71-4284

Intermediate Bulk Containers for Chemicals & Liquids
UF₆ and UO₂ Packaging

**Re: Response to the April 21, 1999 Questions from the Review of the Model No.
ESP-30X Package Application
Docket No. 71-9284**

Figure 1

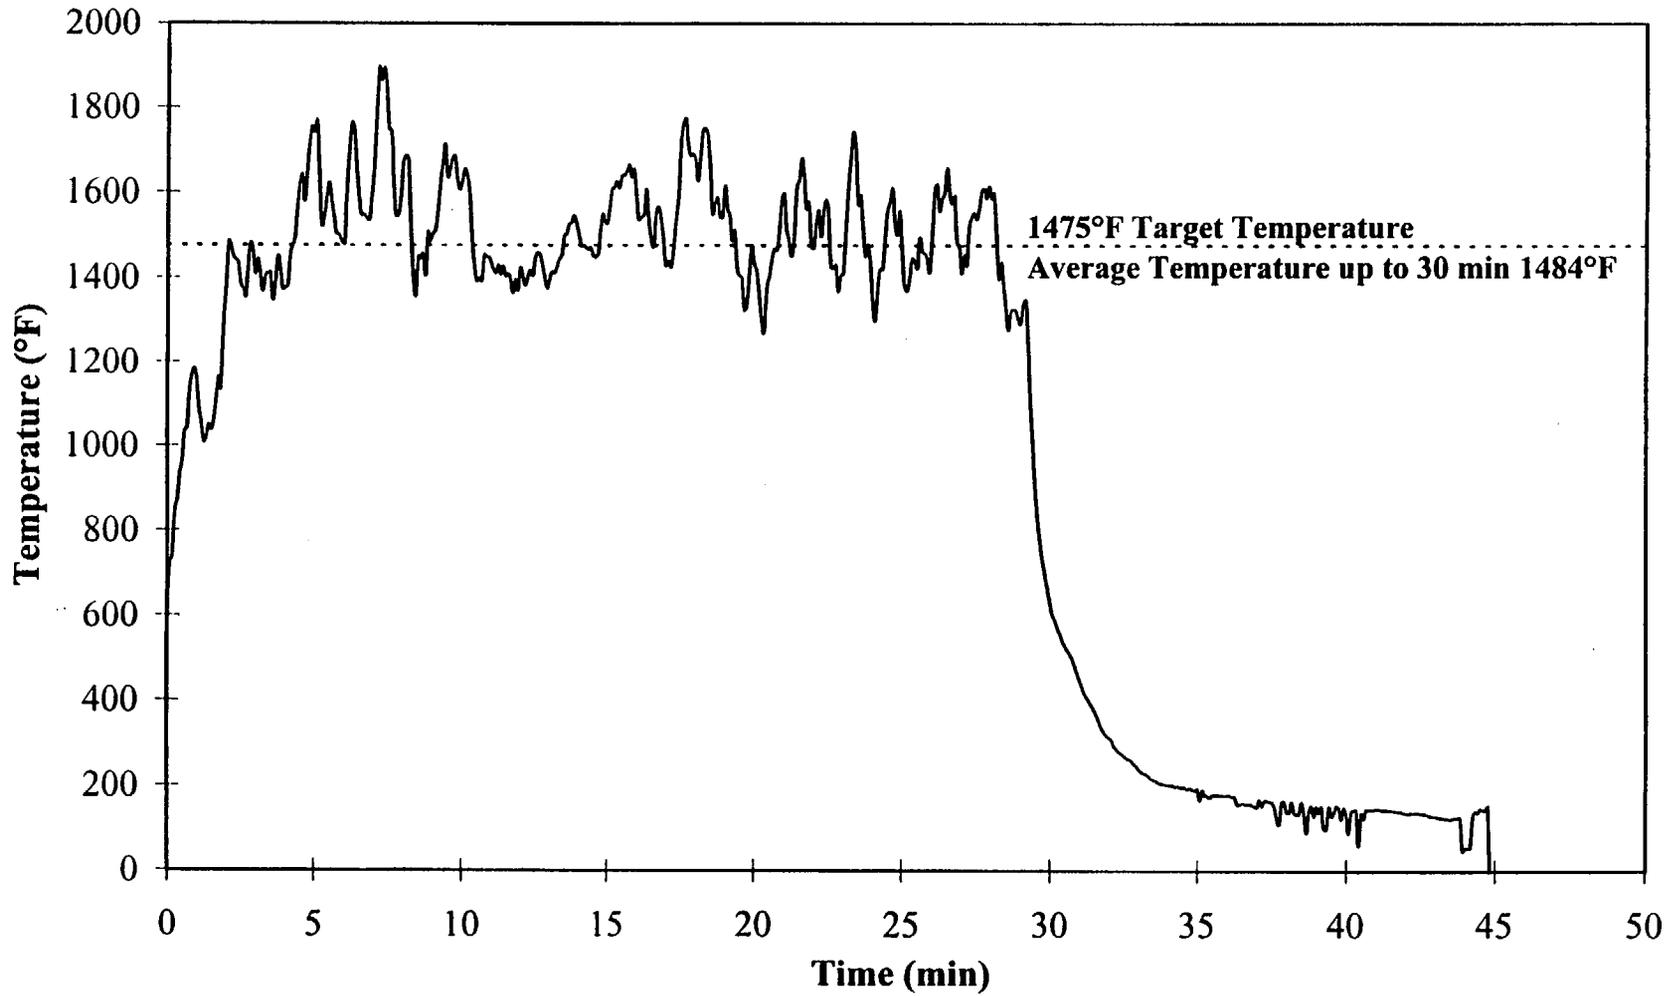
- 1. Revise the application to show that any mass of UF₆, up to the maximum load, will not cause the cylinder to exceed the maximum allowable pressure under the hypothetical accident condition fire test.**
- A1. This answer is provided in the revised Section 3, page 3-13 and Appendix 3.8.2. The conclusion of the analysis provided in Appendix 3.8.2 is "that any mass of UF₆ up to the maximum load, will not cause the cylinder to exceed the maximum allowable pressure of 115 psia under the hypothetical accident condition fire test."
- 2. Revise the application to describe the condition of the temperature labels after the fire test and whether they agreed with the temperatures provided by the thermocouples.**
- A2. The following response is taken from Attachment 1:

Table 9-4 on page 28 of the report shows the maximum temperature reading recorded by the thermocouples during the 30 minute fire exposure period and during the cool down period following the pool fire. Figure 9-11 on page 34 shows the maximum temperature readings indicated by the temperature tags for the duration of the 30-minute fire exposure and cool down period. Temperature tags and post test thermocouple measurements are in agreement. Some of the labels delaminated from the cylinder and no temperature measurements were available.

Table 9 - 4 on page 28 of the report shows the maximum temperature reading recorded by the thermocouples during the 30-min fire exposure period and during the cool down period following the pool fire. Figure 9-11 on page 34 shows the maximum temperature readings indicated by the temperature tags for the duration of the 30-min fire exposure and cool down period. Temperature tags and post test thermocouple measurements are in agreement. Some of the labels delaminated from the cylinder and no temperature measurements were available.
